## **PRELIMINARY PLAT REVIEW RIVERSIDE PLACE SUBDIVISION By Barry Burton**

**RE: RIVERSIDE PLACE SUBDIVISION**  
**Preliminary Review**

Date: January 13, 2016

Our office has completed a review of the preliminary plans dated December 22, 2015.

**Riverside Place Subdivision**  
PART OF THE NW 1/4 OF SECTION 28, T.5N., R.1W., S.1B & M., U.S. SURVEY  
SOUTH WEBER CITY, DAVIS COUNTY, UTAH

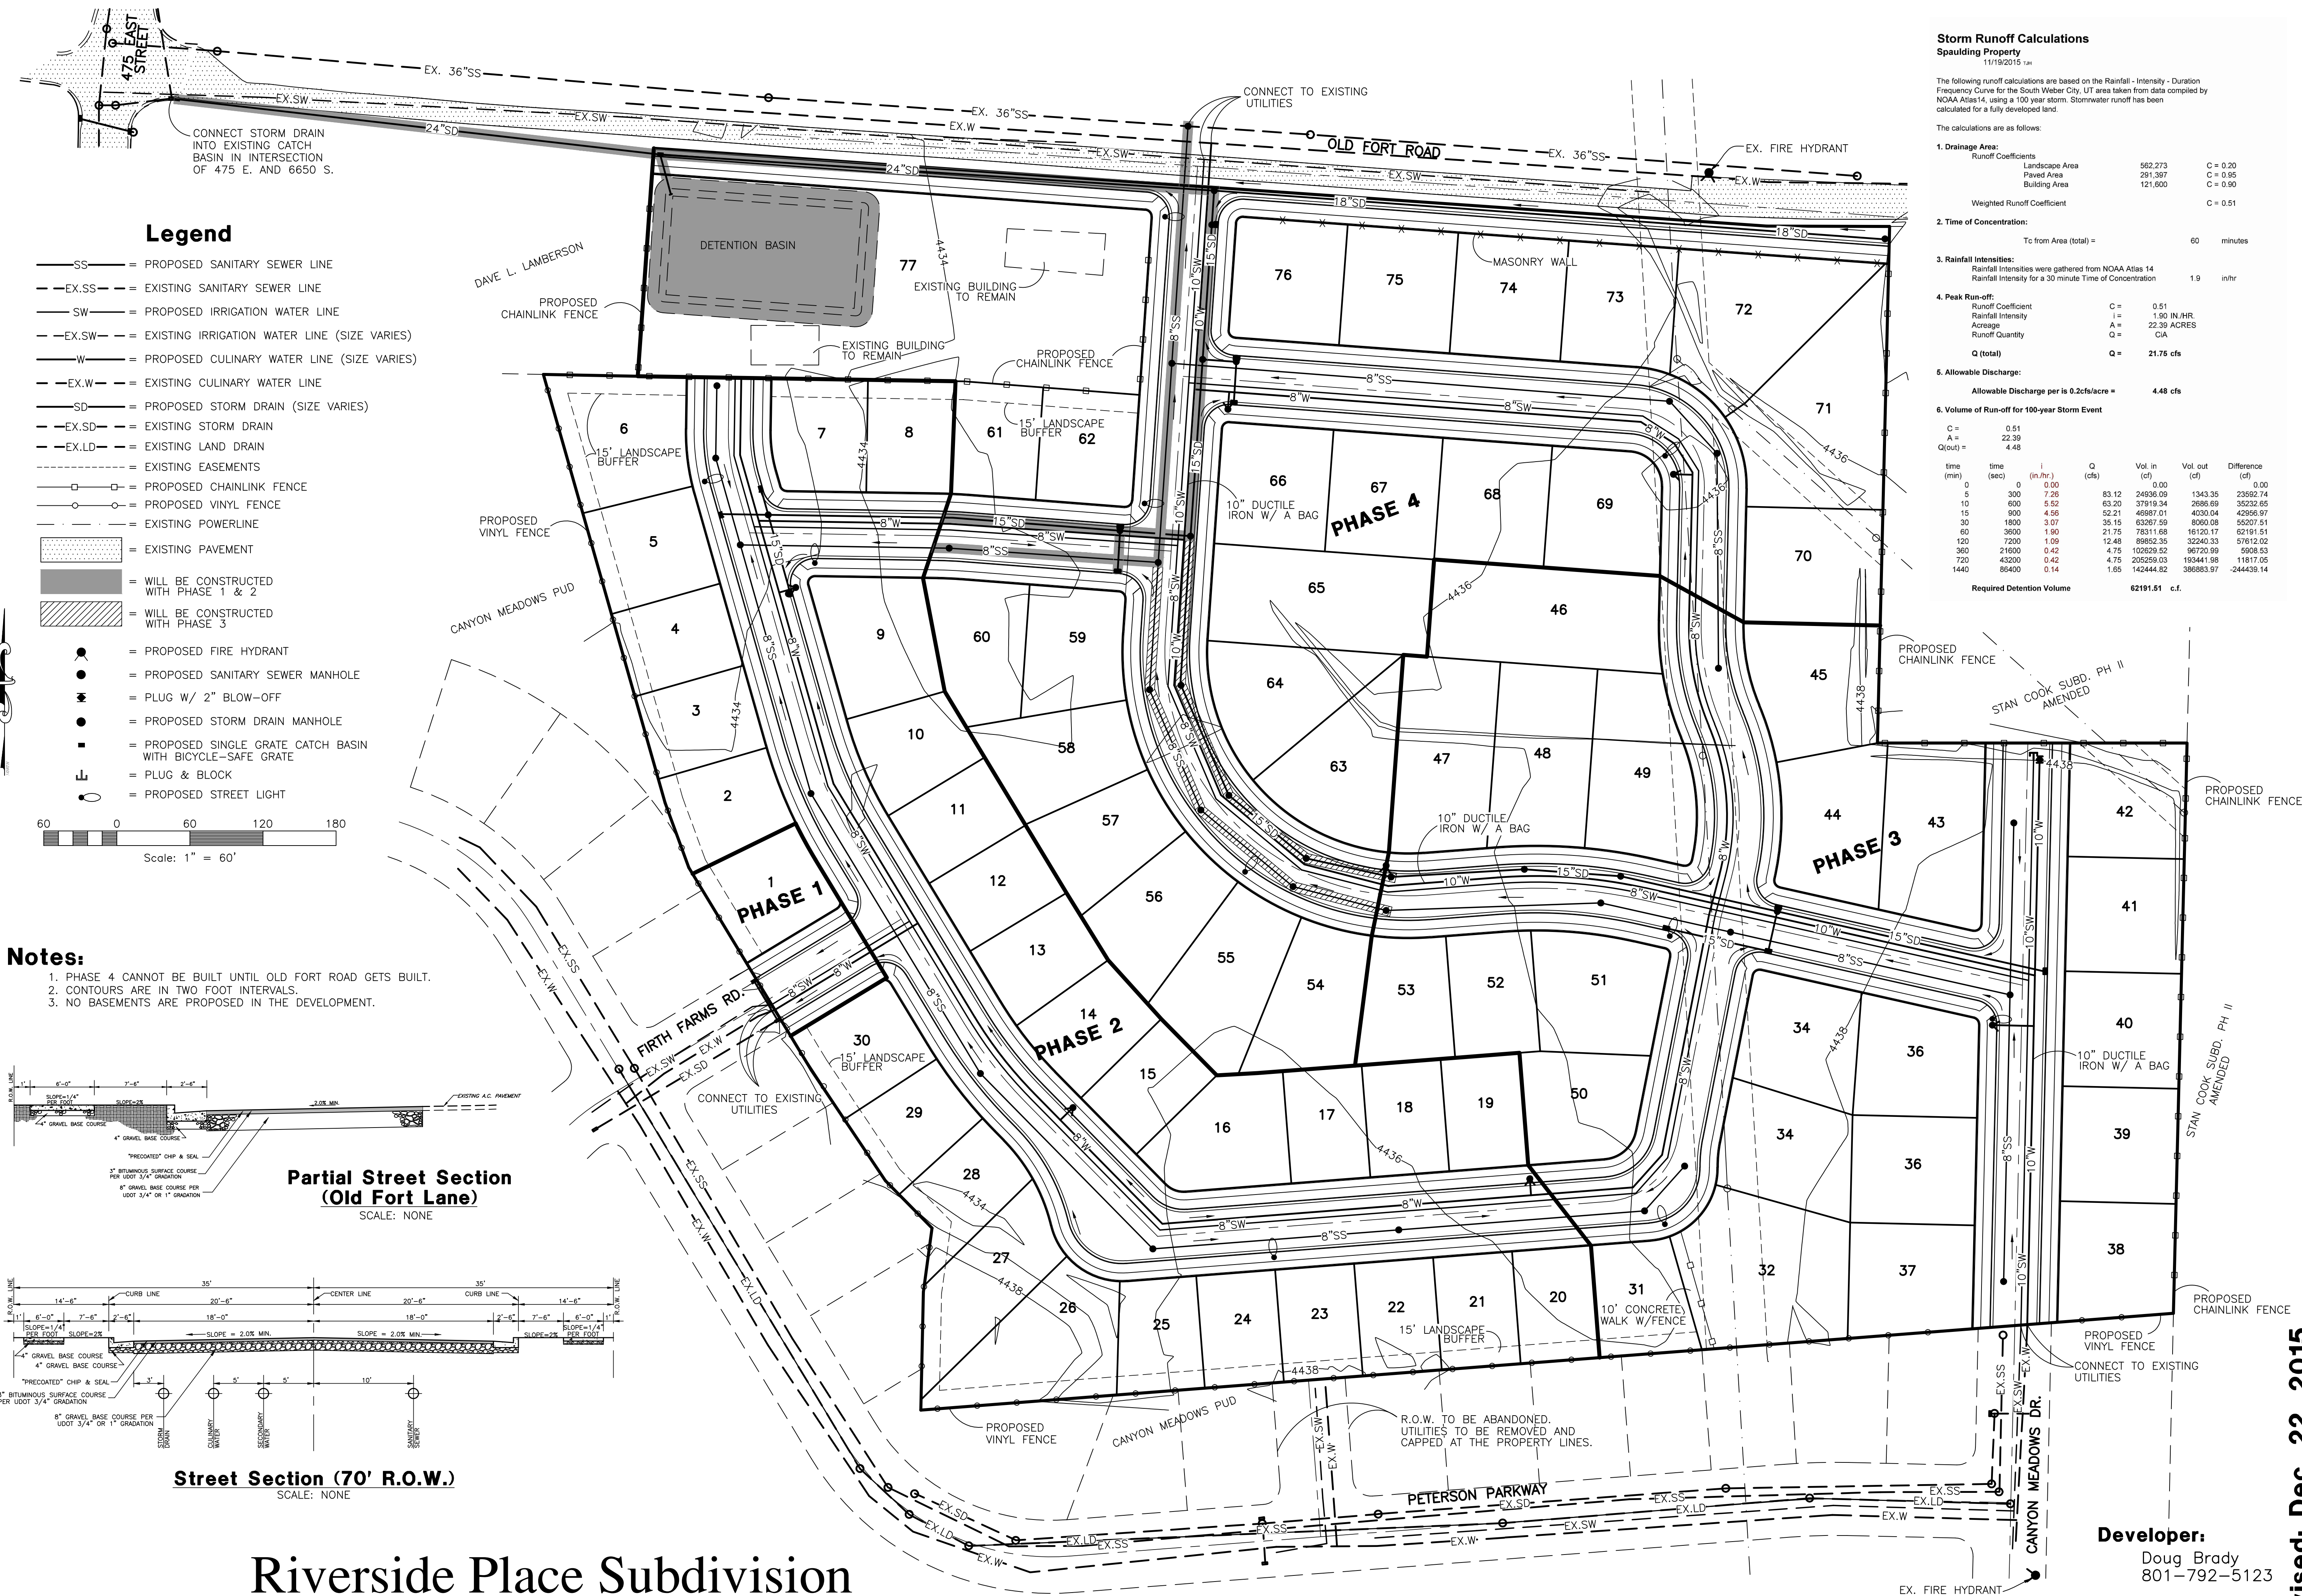
3. Sheet #1. Lot 77 is still zoned R-LM. This should be indicated as such.
4. Sheet #1. Spaulding Dr. should be labeled and indicated that it will be vacated by the City.
5. Sheet #2. Note #1 needs to be changed to read, "Old Fort Road, from 475 East to the east end of the posse grounds, must be built as a part of Phase 3, or the developer's portion of the cost (as identified in the Development Agreement) must be placed in a cash escrow account."
6. Sheet #2. The following note should be added, "A Development Agreement, addressing the developer's responsibility in the development and construction of Old Fort Road must be approved by the City Council prior to approval of Phase 2."
7. Sheet #2. The following note should be added, "The number and exact location of manholes, fire hydrants, inlet boxes, street lights, etc. may need to be adjusted with the final approval of each phase."

8. Sheet #2. A “partial” street section for Old Fort Road was provided. For correct reference, this needs to be replaced with the full cross section of Old Fort Road as adopted by the City Council. Our office can provide that cross section.
9. Sheet #2. In the typical cross section for the 70’ ROW, the thicknesses for the pavement and roadbase should be shown at 3” asphalt and 12” roadbase, but should also indicate “or as currently adopted in the City Standards.”
10. Sheet #2. The developer is responsible to remove the street improvements that constitute Spaulding Dr. and construct curb, gutter and sidewalk across the current street. This should be drawn and the current note revised accordingly.
11. Sheet #2. The existing sewer line in Old Fort Road should be labeled as 30”.
